MEMORANDUM

Date: August 19, 2015
From: Marie Ennis, Gabriel Pardo
To: John Shedd
Company: Chautauqua Institution
c:
Project: Chautauqua Institution Amphitheater Study: Narrative and Questions
Project #: J3262.02

The following is a brief narrative to accompany the two options for structural work shown in the Old Structures Engineering (OSE) drawings originally dated July 15, 2015. The drawings have been revised to better coordinate with the sequence description narrative, and to address a comment from Wendel Architecture and Engineering regarding helical piles.

A.3 STEP 3 - Longitudinal Section. Grid Lines 2 & 8
Scale: 1/16" = 1'-0"

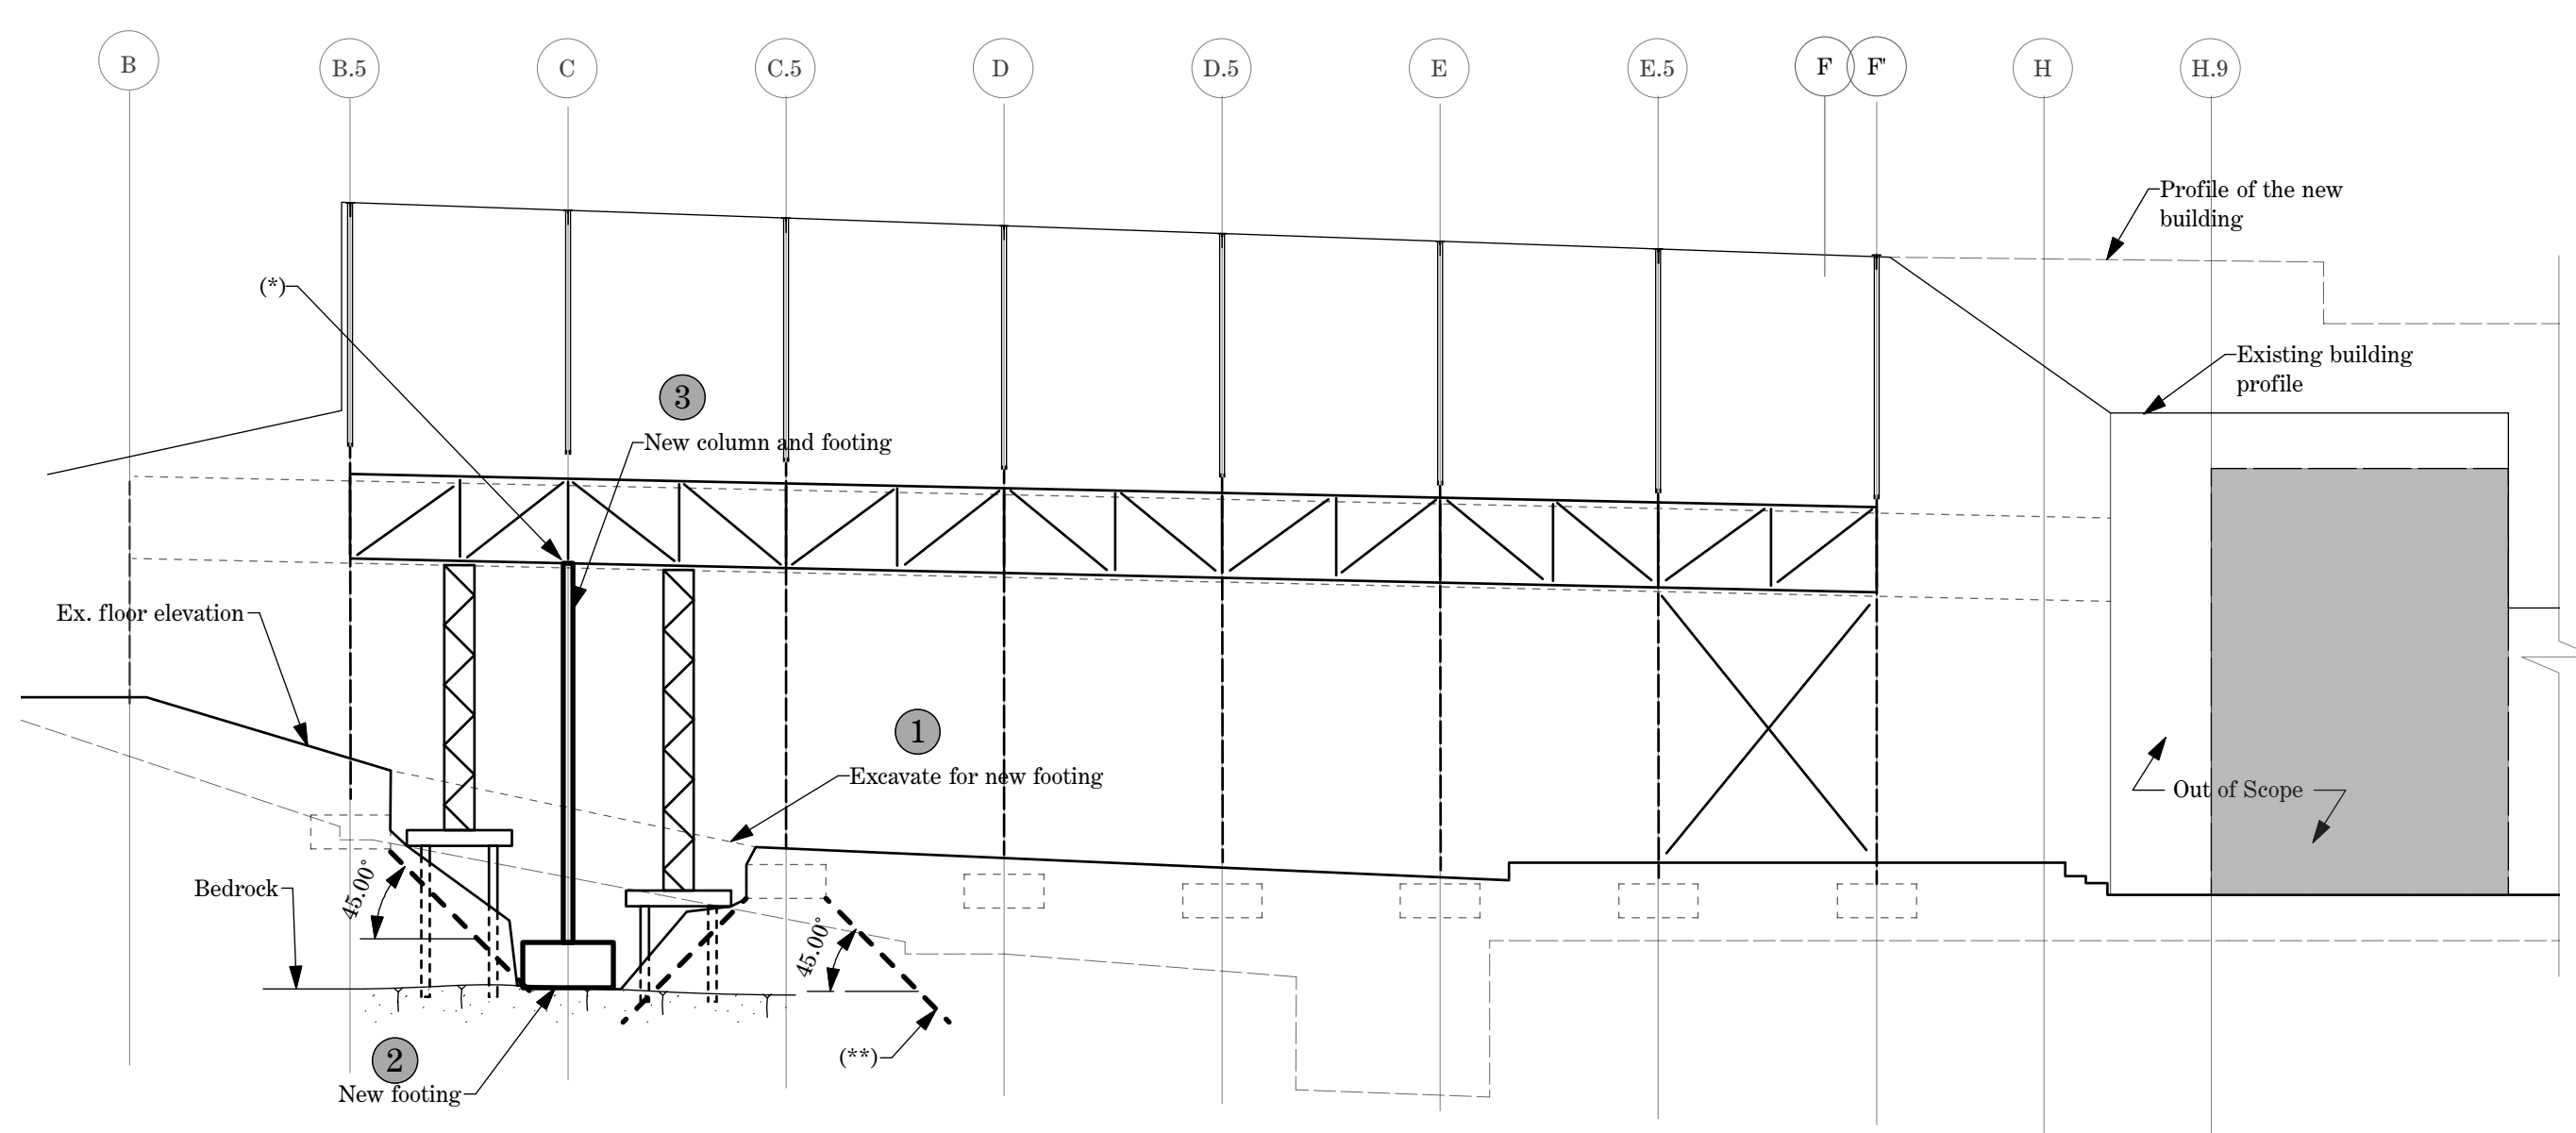
We realize that the helical pile are likely a place holder for some sort of deep foundation system, but we suggest that the helical piles be revised to micro piles as it is atypical to use a helical pile to bear on top of bed rock. Also, it is unlikely to be able to drive helical piles through fragmented/weathered rock to get proper bearing on sound bedrock.

Yes, the helical piles are a place holder. We agree that micro-piles or mini-caissons can bear on, or be socketed into, rock as needed. The drawings have been revised to eliminate reference to helical piles.

A.4 STEP 4 - Longitudinal Section. Grid Lines 2 & 8
Scale: 1/16" = 1'-0"

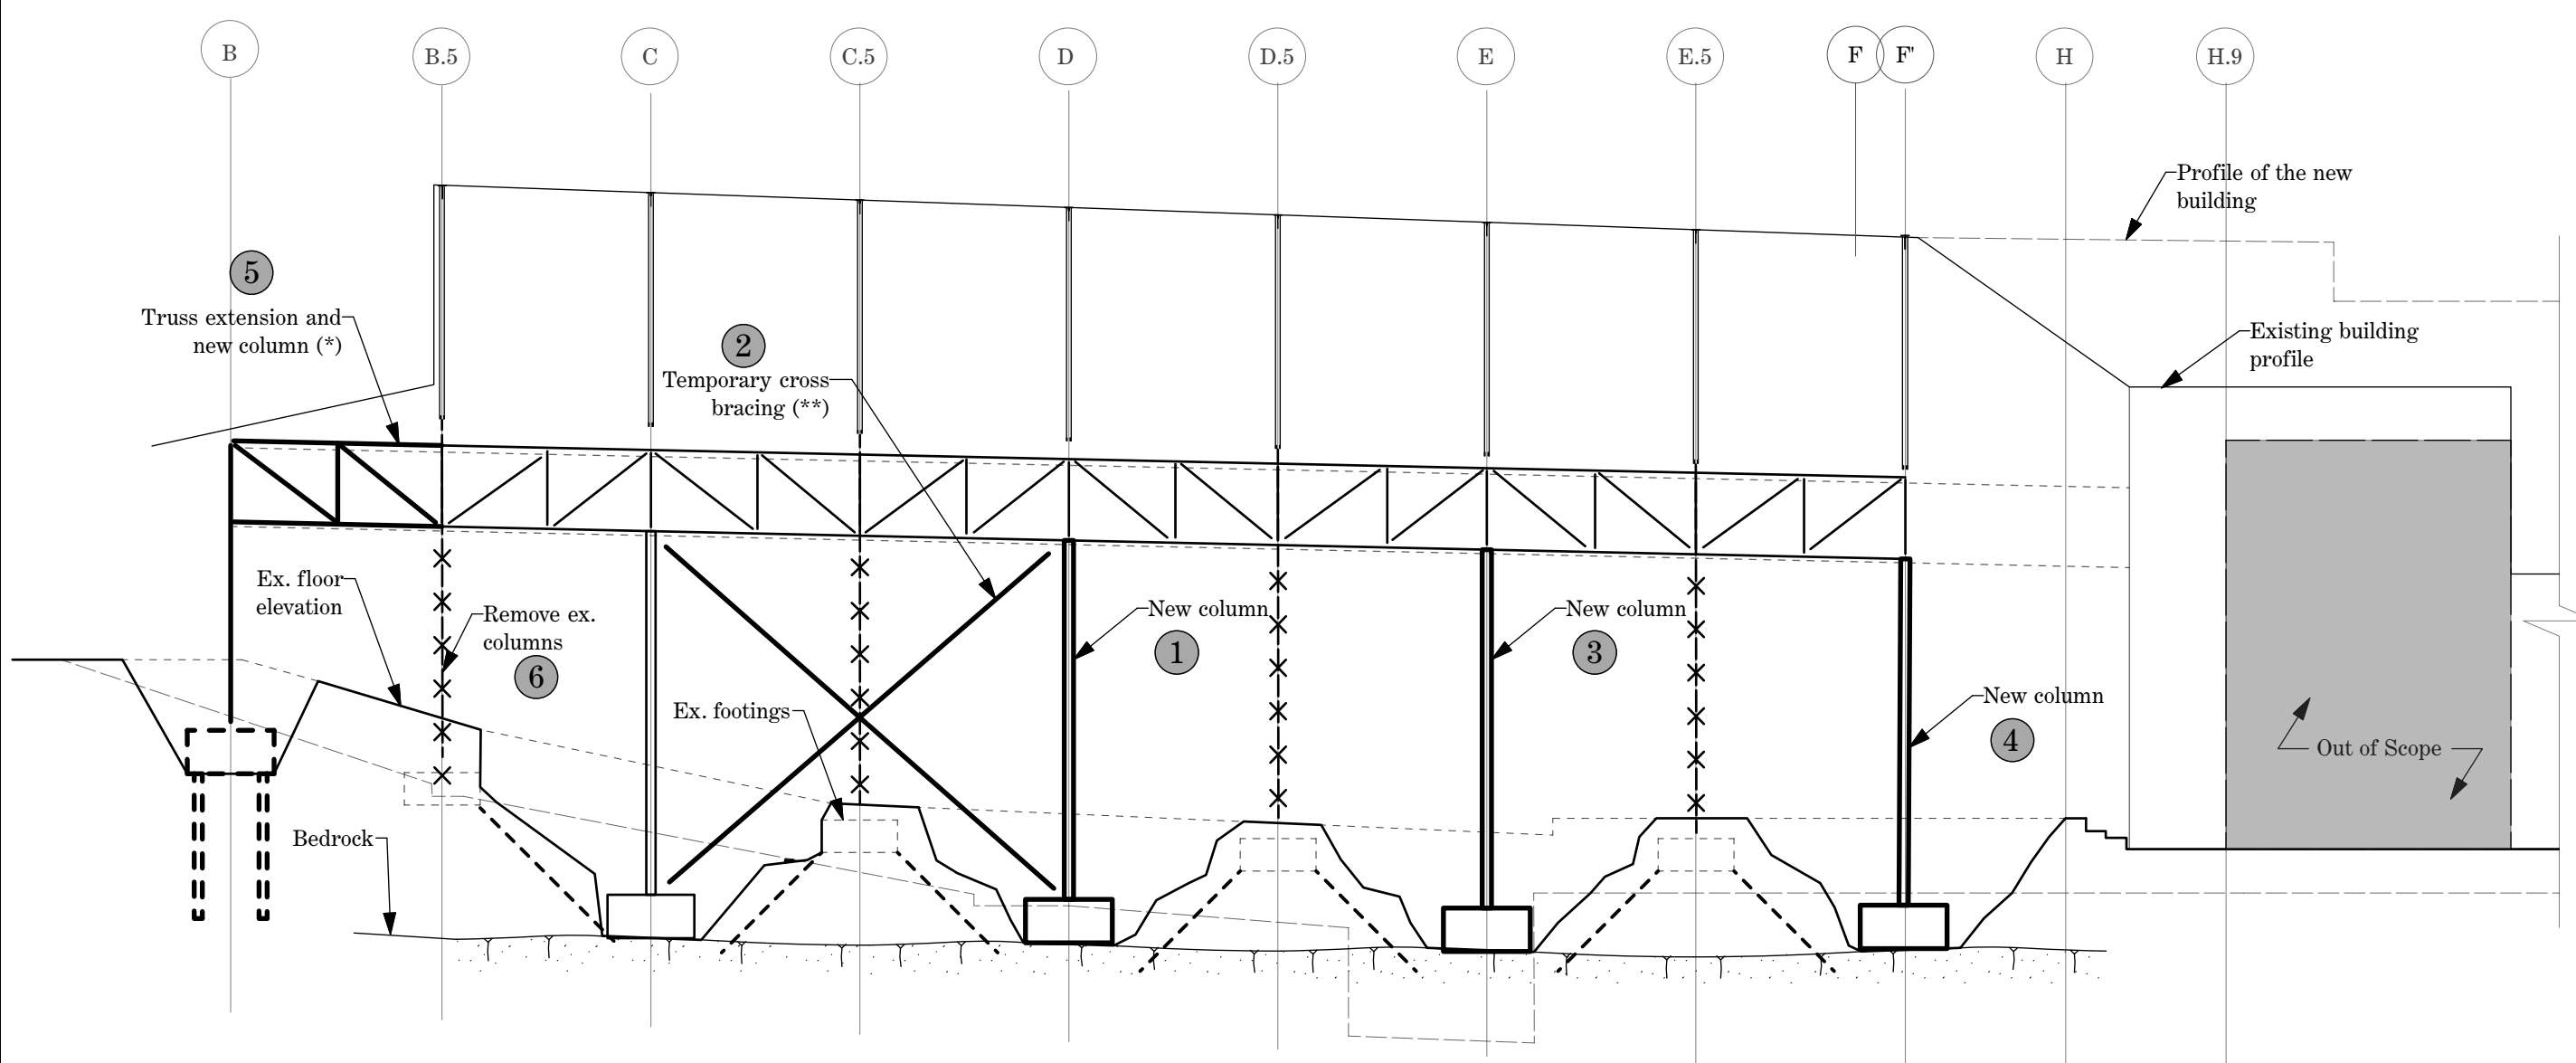
Step 4 likely creates a stability issue if helical piles are used (i.e. to unbraced length of helical pile vs. overturning moment capacity). Again, we recommend that micro piles, socketed into sound bedrock be used in lieu of helical piles.

See response to Step 3 comment.

A.6 STEP 6 - Longitudinal Section. Final Result
Scale: 1/16" = 1'-0"

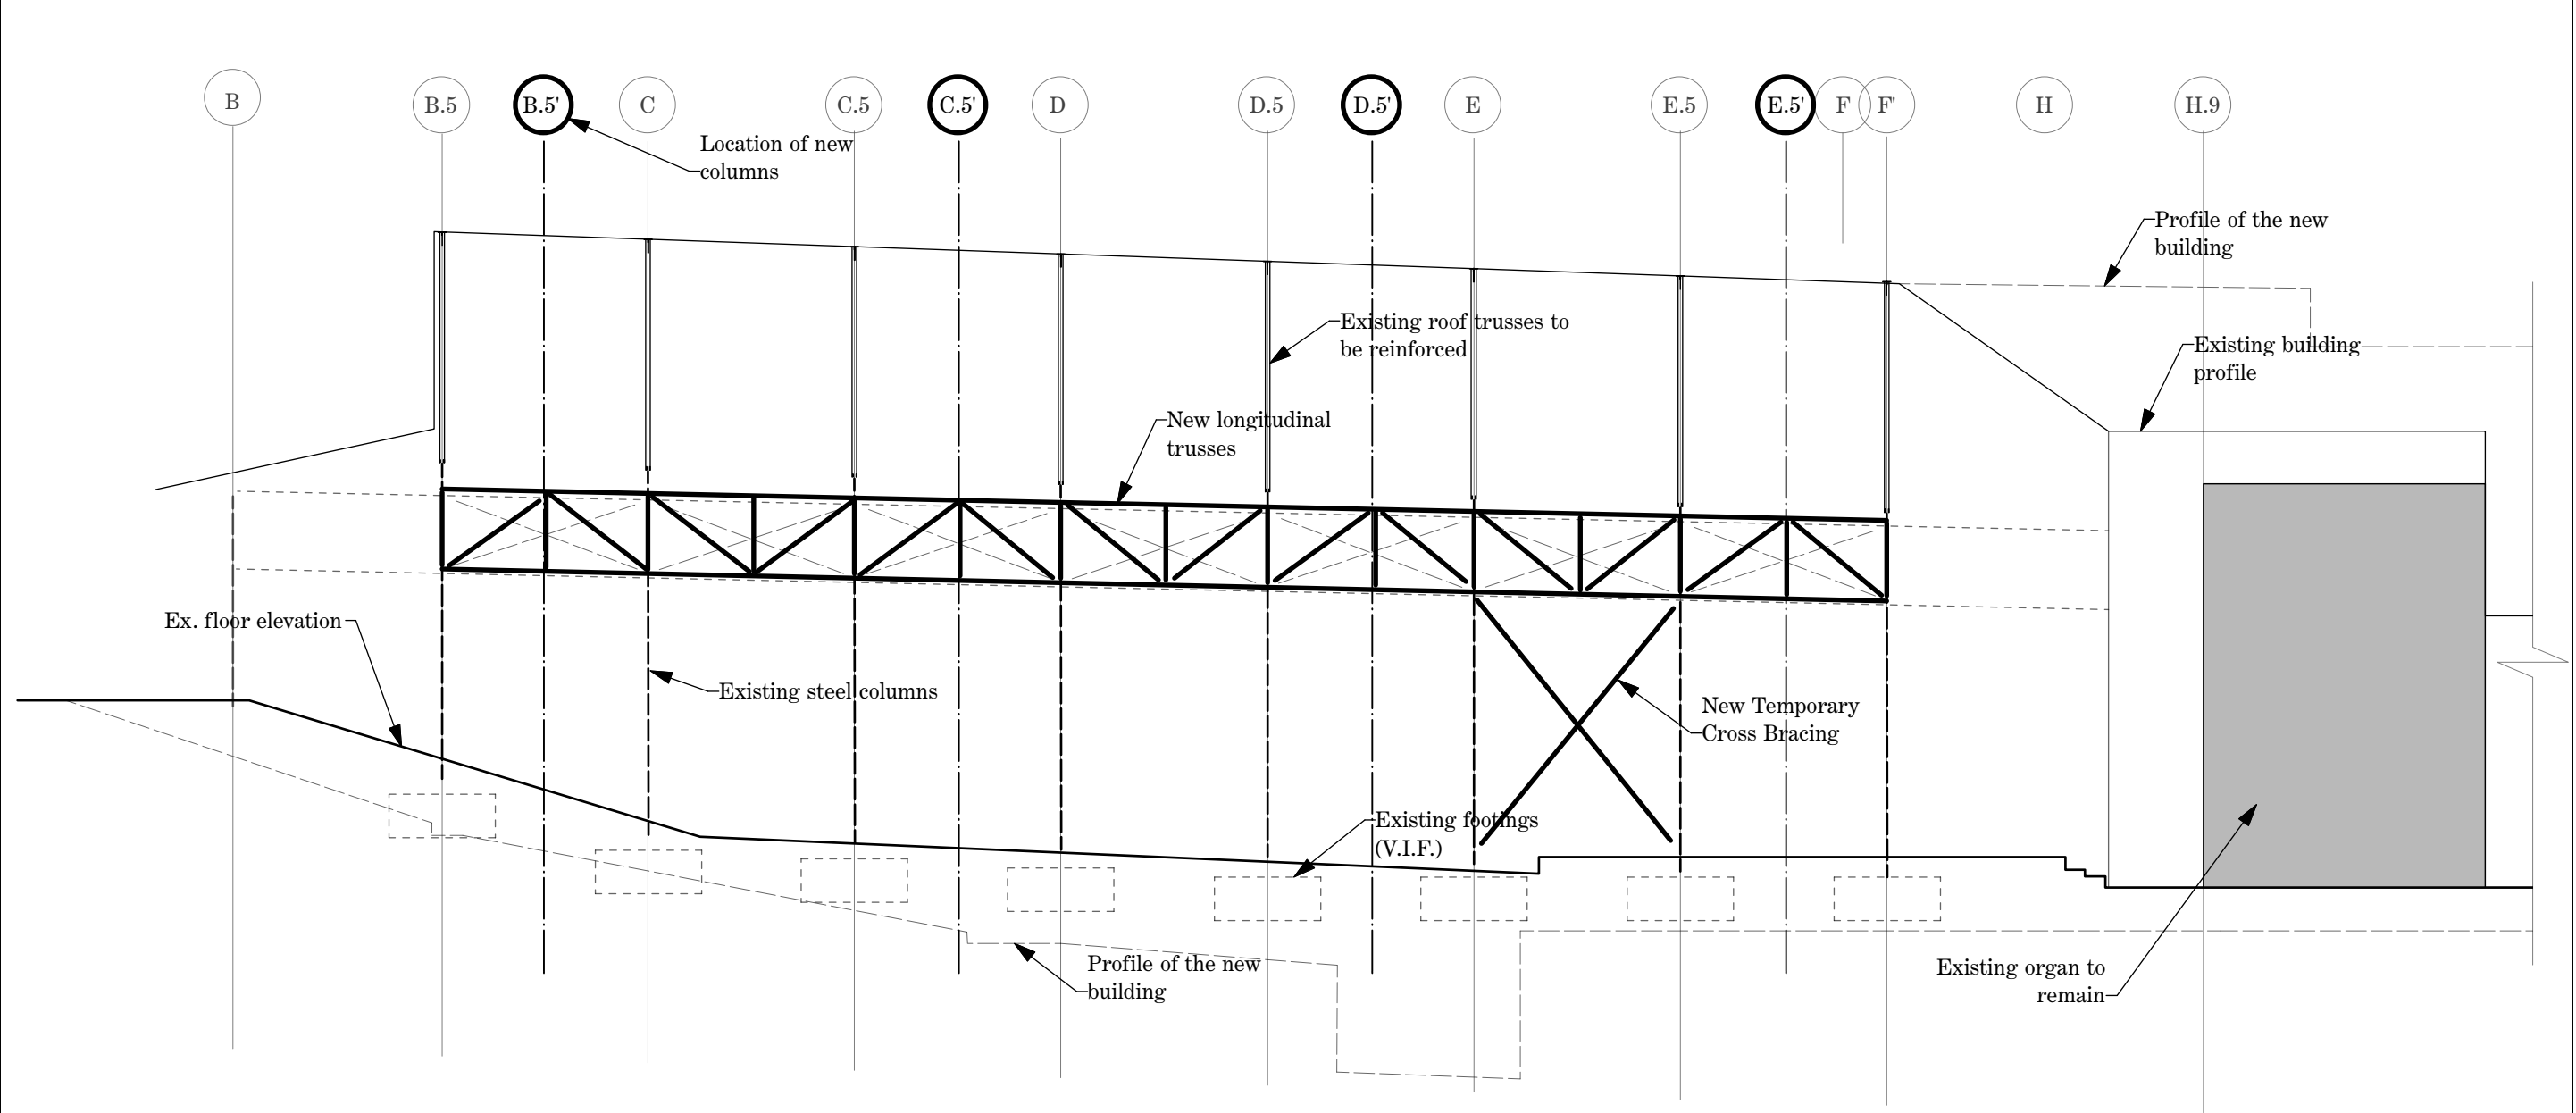
Note A: “Longitudinal truss shall be connected to new east end building to provide lateral stability”. It is not clear if the modifications presented in Option A create a self-supporting structure or if the structure transfers loads into the “New Building” as shown as Out of Scope. Due to the limited amount of space that the “New Building” occupies, it is unlikely that the new building will be able to support any magnitude of lateral load.

Although OSE did not review the new building design, we believe that any load transfer between front-of-house/back-of-house could be accommodated, for example, with shear walls or braced frames, moment frames. A seismic gap may or may not be required, depending on the seismic analysis of the existing building. Given the relative lightness of the roof structure, we believe it is possible that the wind and uneven snow loads govern (which means no separation required). Either way, the existing structure can be detailed to be completely independent of back-of-house structure as needed.
